CITY OF ALLENTOWN

R200 - 2024

Certificate of Appropriateness – 1028 W. Chew Street
Re: Legalization of unauthorized 3rd floor addition, roofing, siding.

Final Staff Review

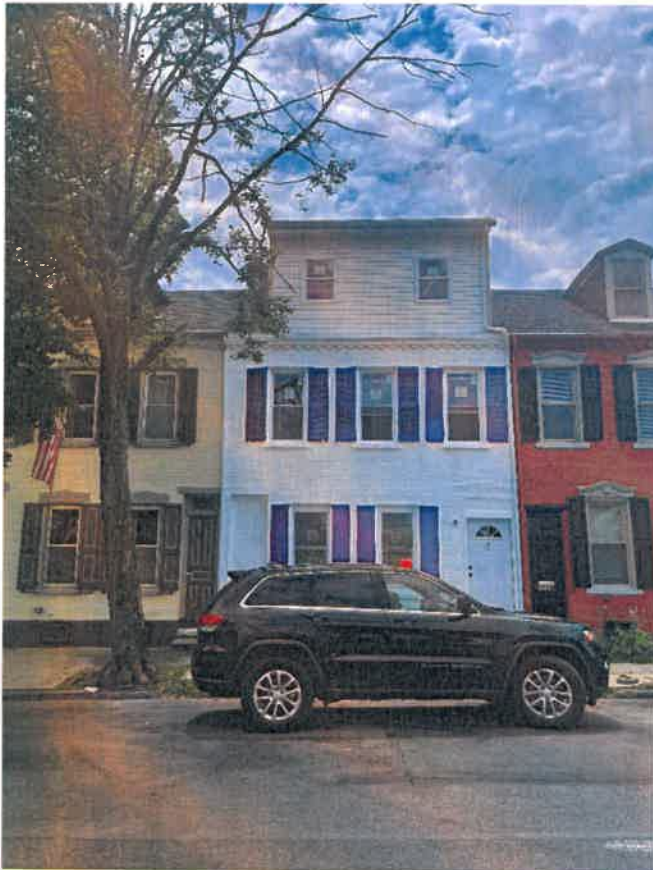
There are several violations with the work performed at 1028 W Chew Street.

- The application describes building new dormers. While there was originally a dormer at the third floor of the house, it was narrow – about the width of the original window. The work has extended the dormer to be nearly the full width of the house, which is not appropriate.

- The installed siding is white vinyl siding. Vinyl siding is not an appropriate material in historic districts.
- No information has been submitted about the type of roofing installed. Materiality and product information would be needed to review the roof.

- There were originally two entry doors to the building along Chew Street. A fiberglass door with a fan lite has been installed at the right entry, which is not appropriate in configuration. A four-panel door that matches the original shown in the previous application would be appropriate. The left side entry door has been removed entirely, and while there is a recess where the doorway and transom were, the door and transom were removed and the opening bricked in and painted. This is not an appropriate treatment.

- The gutters installed appear to be k-style gutters, which are not appropriate. Half round gutters would be an appropriate profile.
- More information is required to review the extent of work at the rear of the building.

- More information is required to review the installed windows.

Staff Recommendation: It is recommended to deny this application.

Rendering, 9/3/2024 (Applicant)

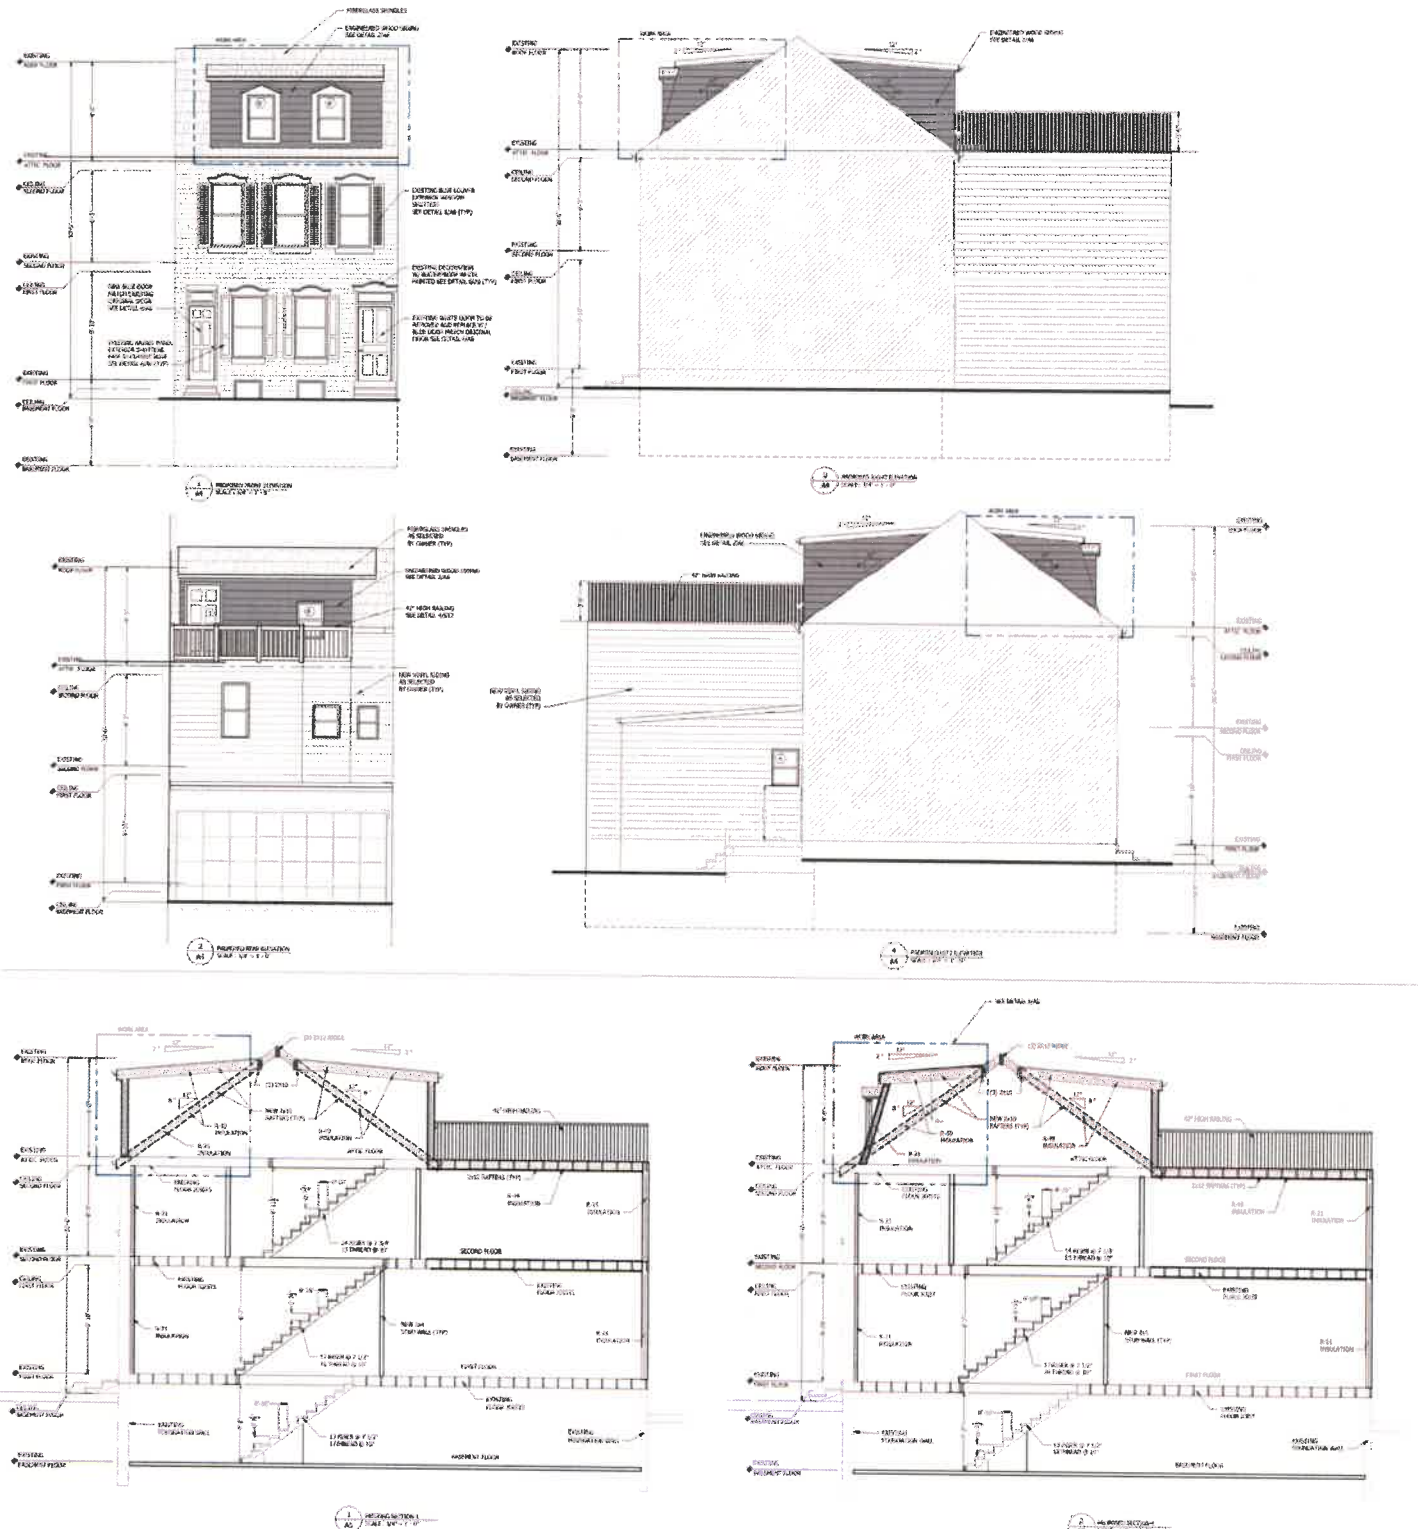
The applicant submitted a rendering of the front of the building along Chew Street with proposed alterations to the work completed to date. Without a supplemental narrative accompanying the rendering, staff observe the following elements of the proposed modifications:

- Windows protruding from the third-floor addition, to allude to the geometry of neighboring dormers
- Modified materials at the third-floor addition walls to replace the vinyl siding. More information is needed to comment on the proposed alternate material.
- Paneled doors at the main entry and grocer's alley

While these proposed modifications do not eliminate or reduce the third-floor addition, the applicant appears to be taking steps to mitigate the negative effects of the new work.

This rendering is the only updated material received by staff prior to the 9/9/2024 HARB hearing, and there were no submitted materials related to the rear of the property.

Discussion: The applicant noted his engineer made revisions to the drawings based on the comments from last month to try to mitigate the negative impacts. Mr. Jordan noted this application will most likely have to be discussed with council since HARB cannot approve it based on form, scale, massing, and materials, but appreciates the work done to make the revisions. Mr. Huber noted specific materials should be provided to indicate how the design will comply with the historic ordinance. The applicant noted frustration with the code review process.

Action: Mr. Jordan moved to deny the application presented on September 9, 2024 for the roofing, door, and window replacement at 1028 W Chew Street because it did not comply with the Guidelines for Historic Districts: Chapter 3, Section 3.1 – Roofs, Section 3.5 – Windows, and Section 3.6 – Doors and there were no known unique circumstances that would apply.
